October 4, 2017

## Engineering Change Notification

### **NHD-C12864LZ-FSW-FBW-3V3**

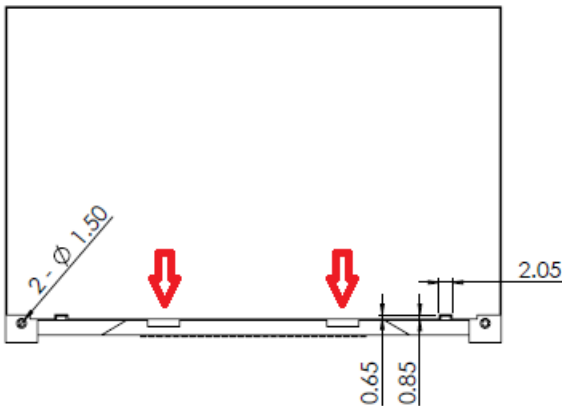
The backlight module on this display has been redesigned to include new latches to better secure the PCB which holds the backlight LEDs.

These latches do not exceed the gap between the backlight frame and display pins, and will not cause an obstruction during the installation and operation of the display.

We also made a change to the LCD glass in order to improve the display contrast for a more black & white appearance.
